**Re: Lot 20 Block 5 SAD 228  
Volcano Cliffs Subdivision Unit 19  
7831 Urraca Rd. NW  
Grading and Drainage Plan  
Engineers Stamp Date 4/17/2022 (D10D003H20)  
Pad Certification Date 6/3/2022  
CO Certification Date 3/17/2023**

Based on the Certification received 3/22/2023, the site cannot be accepted for release of Certificate of Occupancy by Hydrology until the following comments are addressed.

ENGINEER'S SEAL  4/17/22 DAVID SOULE P.E. #14522	Lot 20 Blk 5 Un 19 VC 7831 Urraca Street NW <b>GRADING AND DRAINAGE PLAN</b>  PO BOX 89924 ALBUQUERQUE, NM 87199 (505) 321-8099	DRAWN BY DEM
		DATE 4-15-22 Lot 20 Blk 5 Un 19 VC .dwg SHEET # C1 JOB #

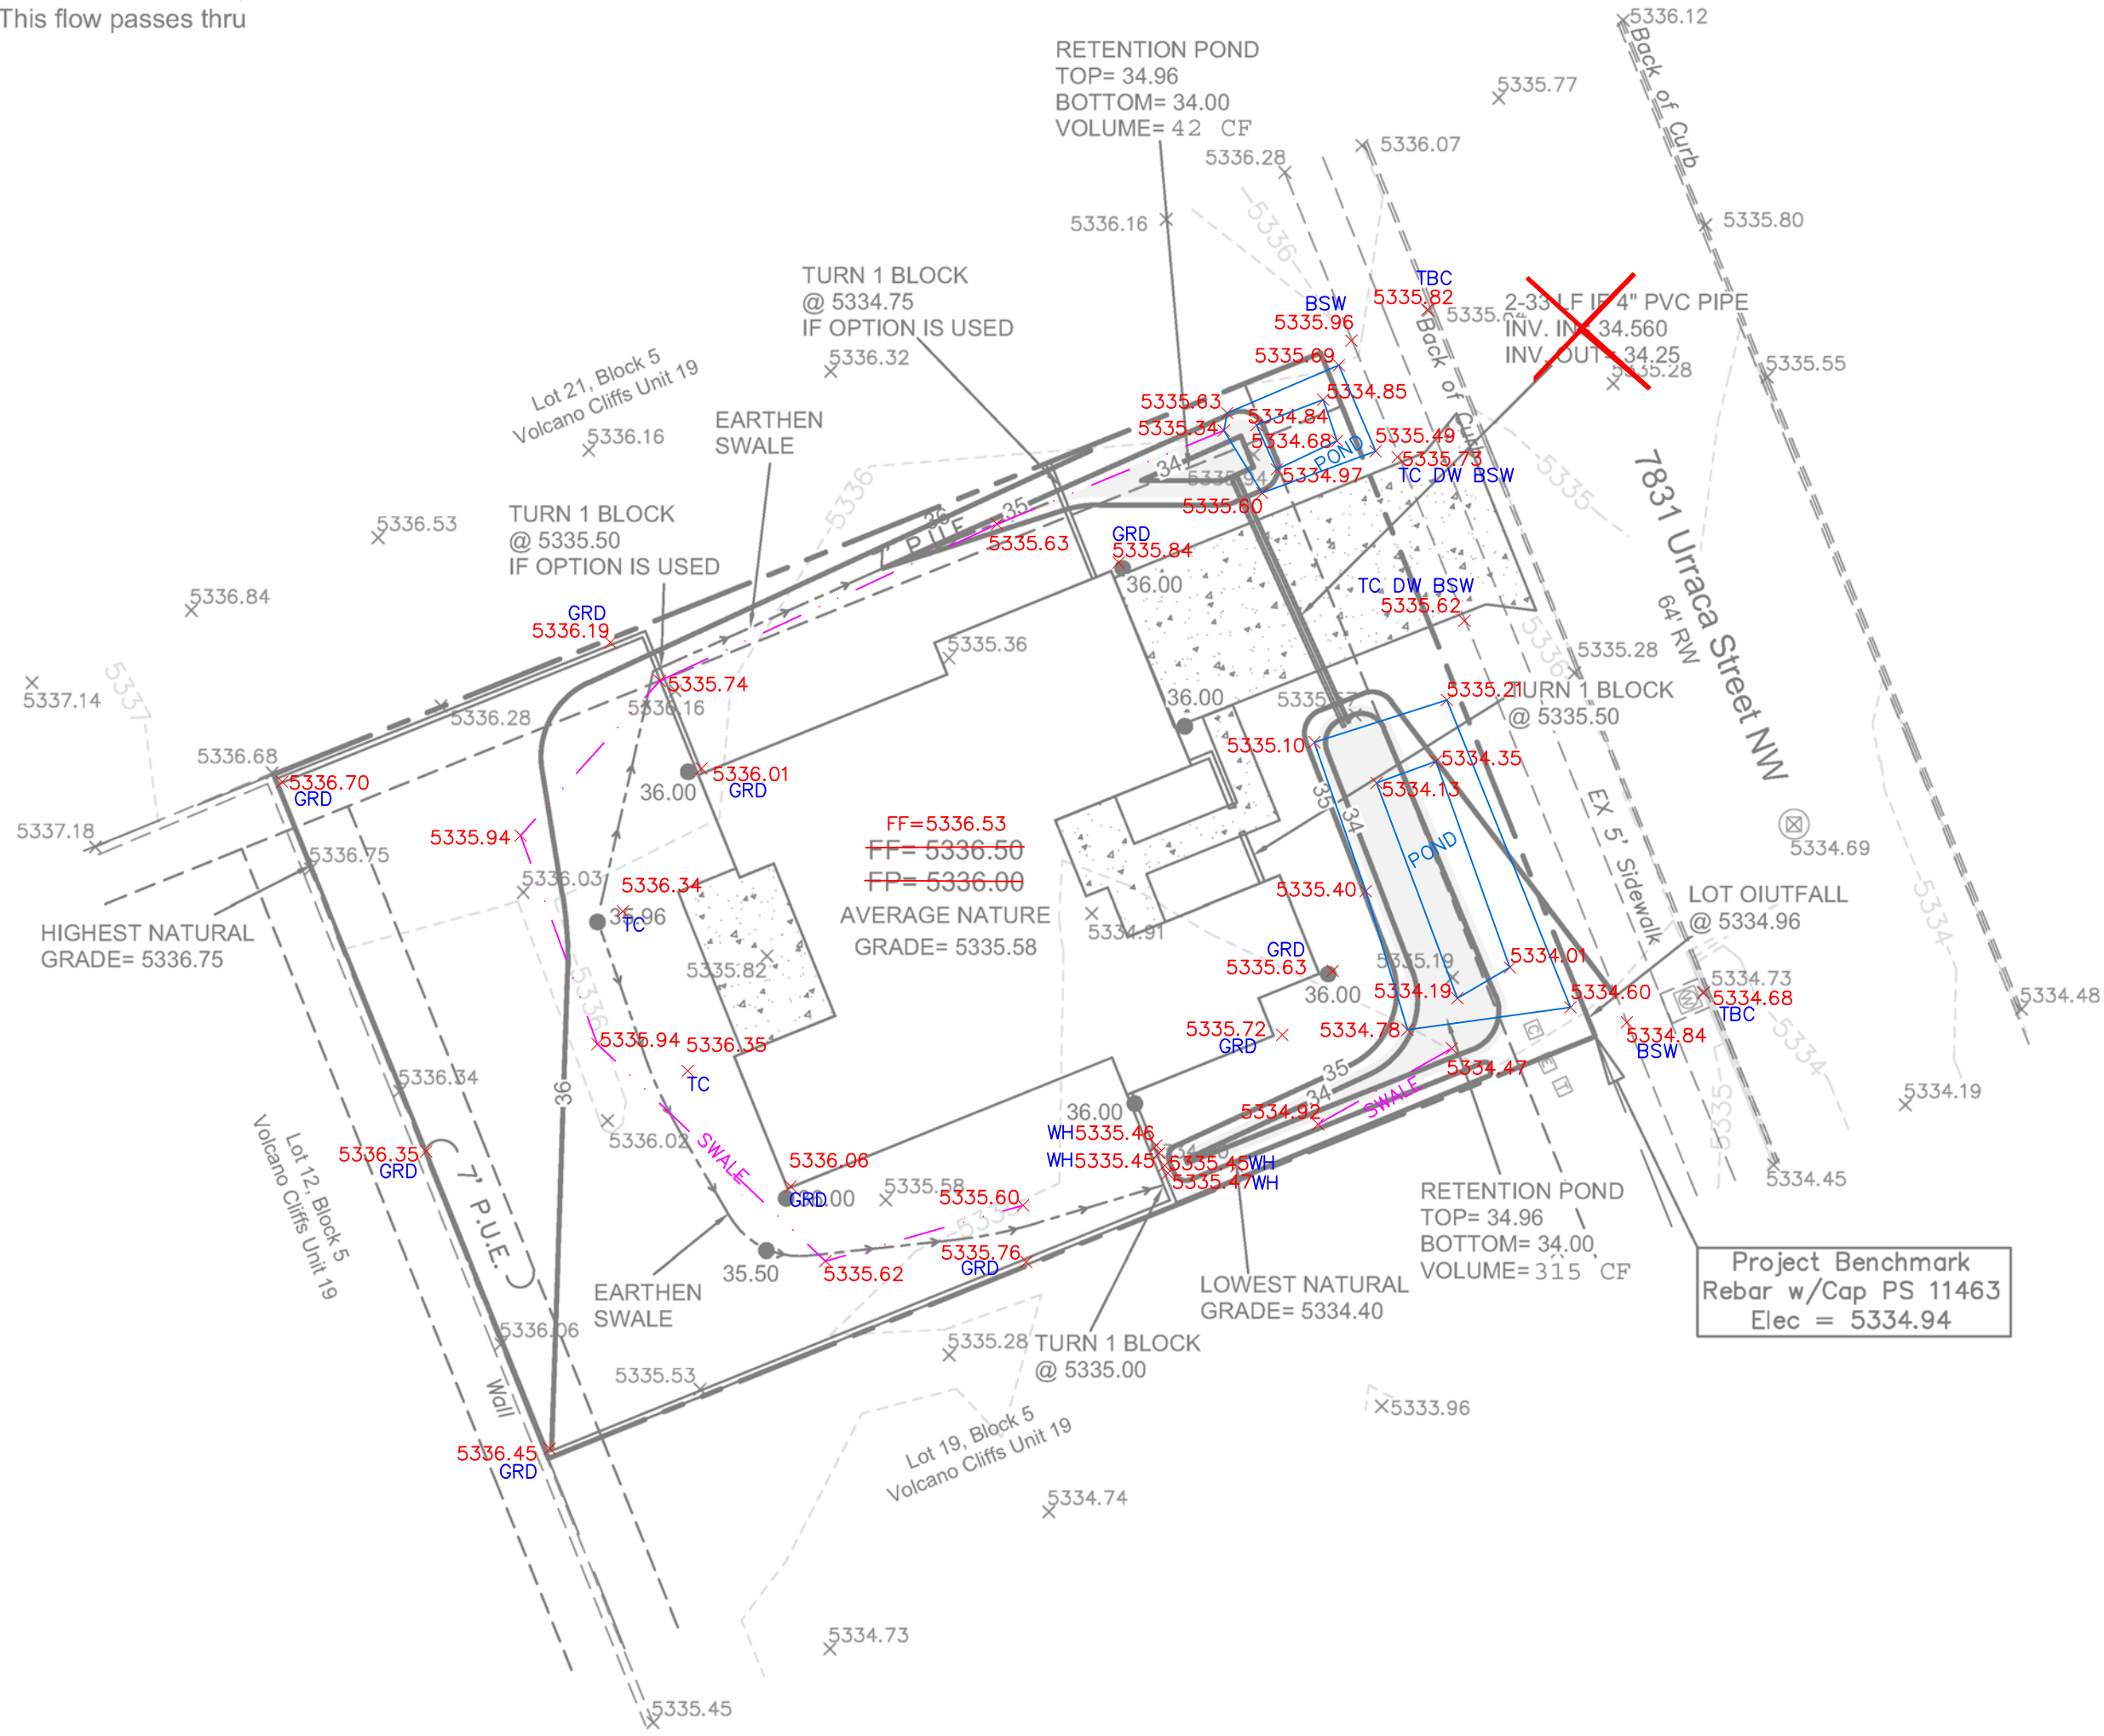
- All ponding areas and swales need to have gravel in place.
